**Consultation Response from KC, Conservation & Design****2023/93445 & 2023/93446 145, Church Street, Netherthong, Holmfirth, HD9 3EA****Erection of garage and gym/office (Listed Building within a Conservation Area)****Listed Building Consent for erection of garage and gym/office (within a Conservation Area)****Date Responded: 12.12.2023****Responding Officer: S Pickles****Responding Ref:**

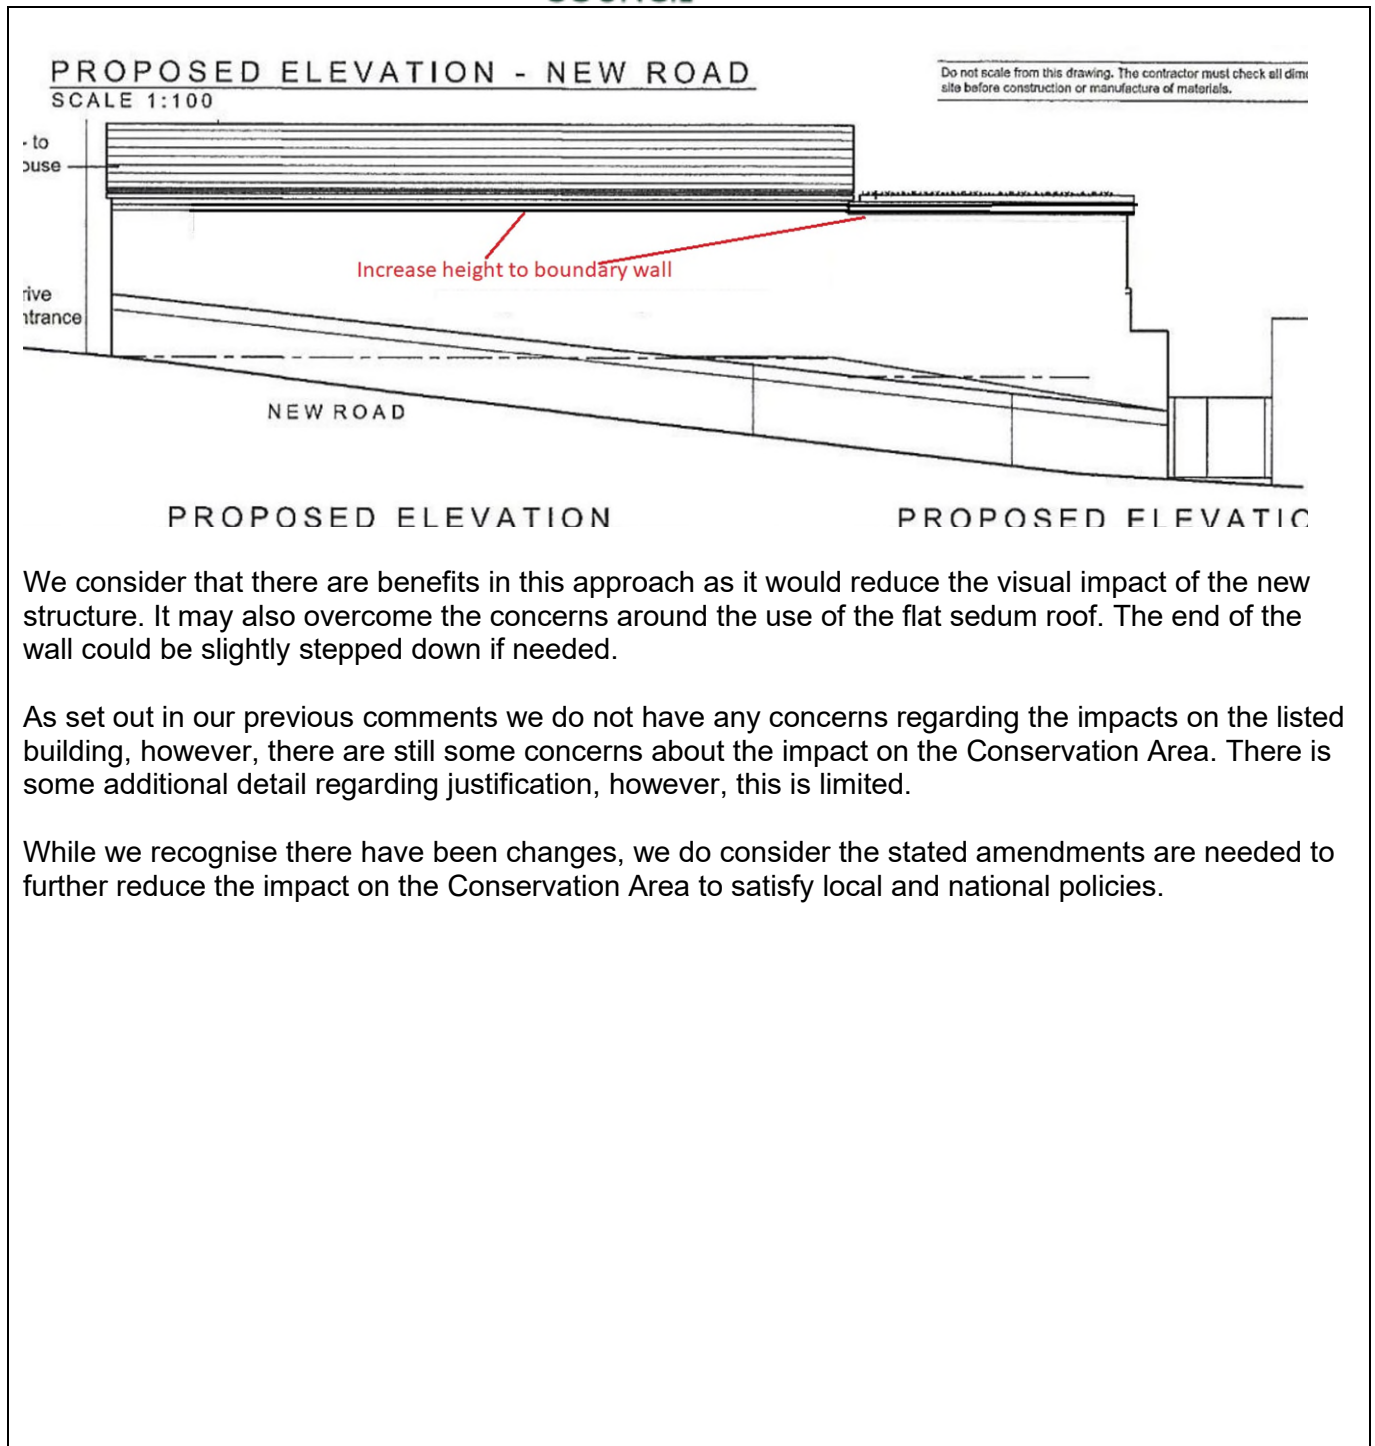
The side wall facing the roadside has been amended removing the timber cladding and it is now proposed to be coursed natural stone. We had previously advised on this and stated '*In respect of the timber cladding and roof detail, we consider that this could be addressed in the following manner. The height of the existing rebuilt boundary wall be increased to the height of the garage.*

While the submitted plans do remove the cladding and now propose natural stone, we do consider that the existing boundary wall should be increased in height. We have illustrated this below in a sketch plan.

We consider that there are benefits in this approach as it would reduce the visual impact of the new structure. It may also overcome the concerns around the use of the flat sedum roof. The end of the wall could be slightly stepped down if needed.
